[Docket No. FAA-2006-24074; Directorate Identifier 2005-NM-213-AD]

Airworthiness Directives; Bombardier Model CL-600-2C10 (Regional Jet Series 700, 701, & 702) Airplanes, Model CL-600-2D15 (Regional Jet Series 705) Airplanes, and Model CL-600-2D24 (Regional Jet Series 900) Airplanes

ACTION: Notice of proposed rulemaking (NPRM).

Bombardier, Inc. (Formerly Canadair):
Docket No. FAA-2006-24074;
Directorate Identifier 2005-NM-213-AD.

Figure 1
LH side shown
RH side opposite

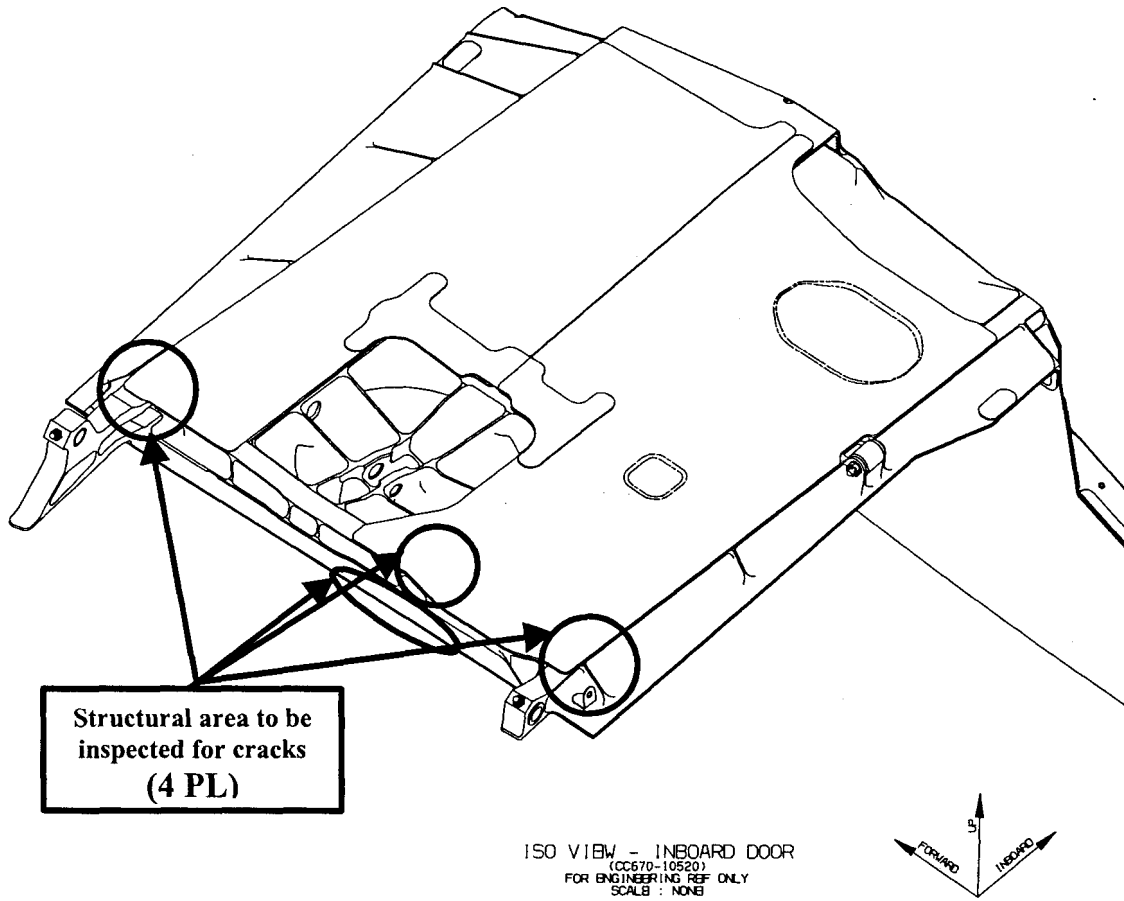
(g) For Model CL-600-2C10 (Regional Jet series 700 & 701) series airplanes, S/Ns 10003 through 10999 inclusive; and Model CL-600-2D24 (Regional Jet series 900) series airplanes, S/Ns 15002 through 15990 inclusive: At the applicable time specified in paragraph (f) of this AD, perform detailed inspections of the lower panel, part number (P/N) CC670-10520, of the left- and right-hand MLG doors for the conditions and in the areas specified in paragraphs (g)(1), (g)(2), (g)(3), and (g)(4) of this AD; and Figures 1, 2, and 3 of this AD.

Figure 2
View LKG INBD
LH side Shown
RH side Opp

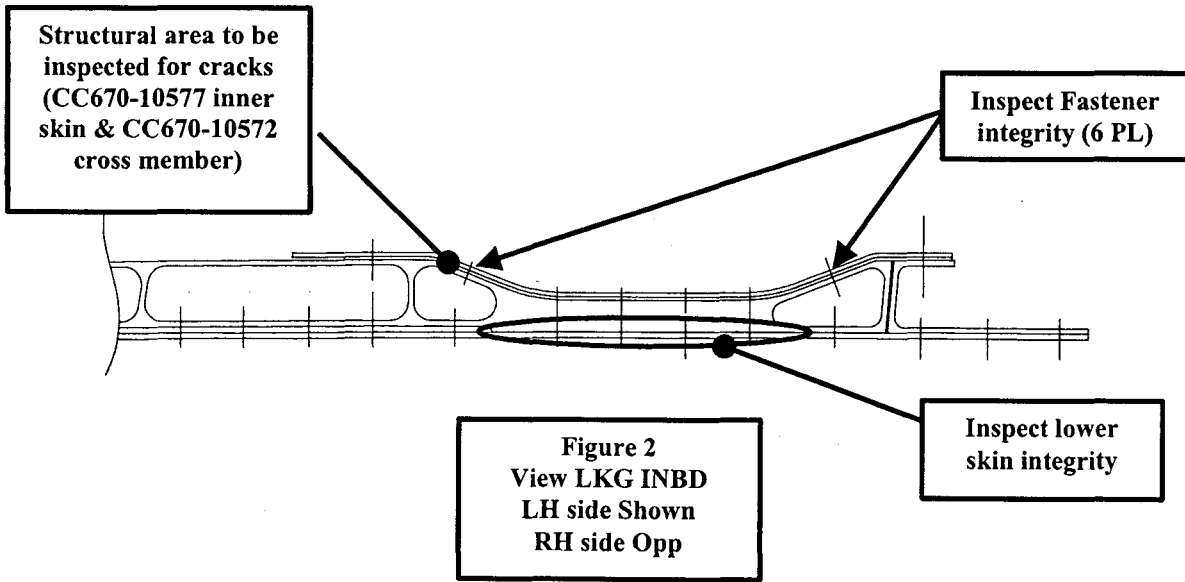
(1) Inspect the cross member, P/N CC670-10572, of the MLG door lower panel for cracking or deformation, in accordance with Figure 2 of this AD.

(2) Inspect the inner skin, P/N CC670-10577, of the MLG door lower panel at the

cross member (P/N CC670-10572) for cracking or deformation, or pulled or missing fasteners, in accordance with Figure 2 of this AD.

(3) Inspect the outer skin, P/N CC670-10574, of the MLG door lower panel at the cross member (P/N CC670-10572) for cracking or deformation, or pulled or missing

fasteners, in accordance with Figure 2 of this AD.

Figure 3
View LKG INBD
LH side Shown
RH side Opp

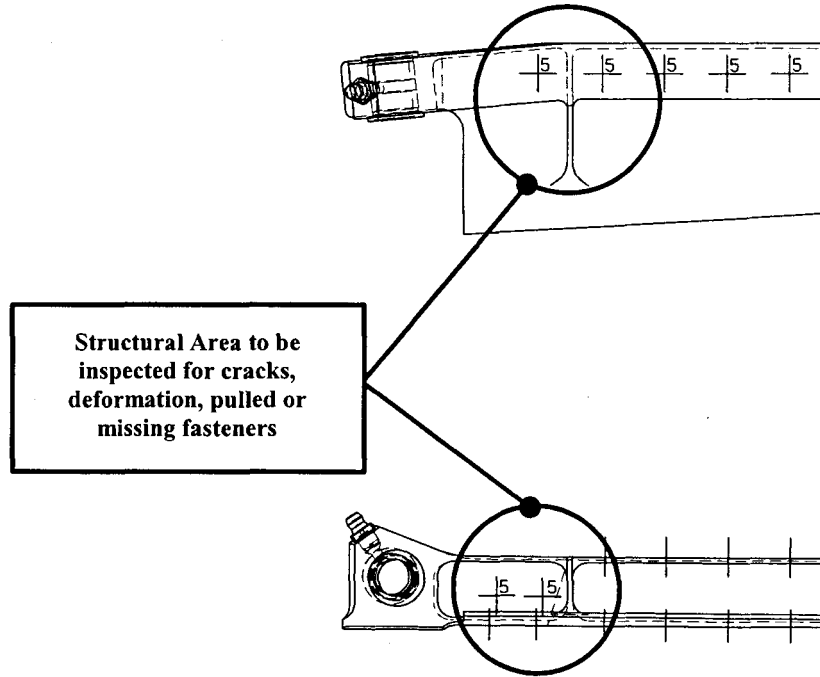
(4) Inspect the forward member, P/N CC670-10570, and aft member, P/N CC670-10571, of the MLG door lower panel, for cracking or deformation, or pulled or missing fasteners, in accordance with Figure 3 of this AD. Figures 1 through 3 of this AD follow.
